Access Compliance Report

Public Rights-of-Way

Intersection ID: 2977	Main Street: ELDESLIE_DR	Cross Street: HARBURN_FOREST_DR	Location: NE
ADA ID: 70AD9CFAEF51	Ramp Type: BlendTrans1	Initial Pass/Fail: Pass	Overall Compliance: No
Severity Score: 0.25			
Codes/Mitigation Info/Possible Solution		Field Measurements/Component Compliance

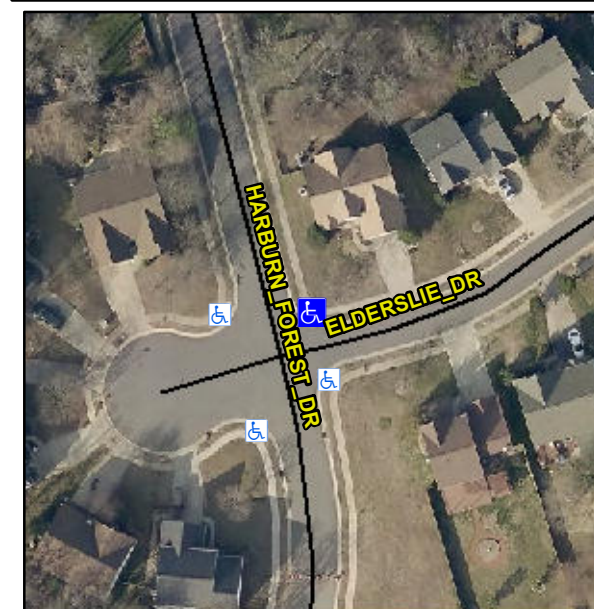
DAMAGED GTR

R304.5.3, R304.2.1, R305.2

Remove & Replace Curb Ramp With Two New Directional Ramps or Equivalent.
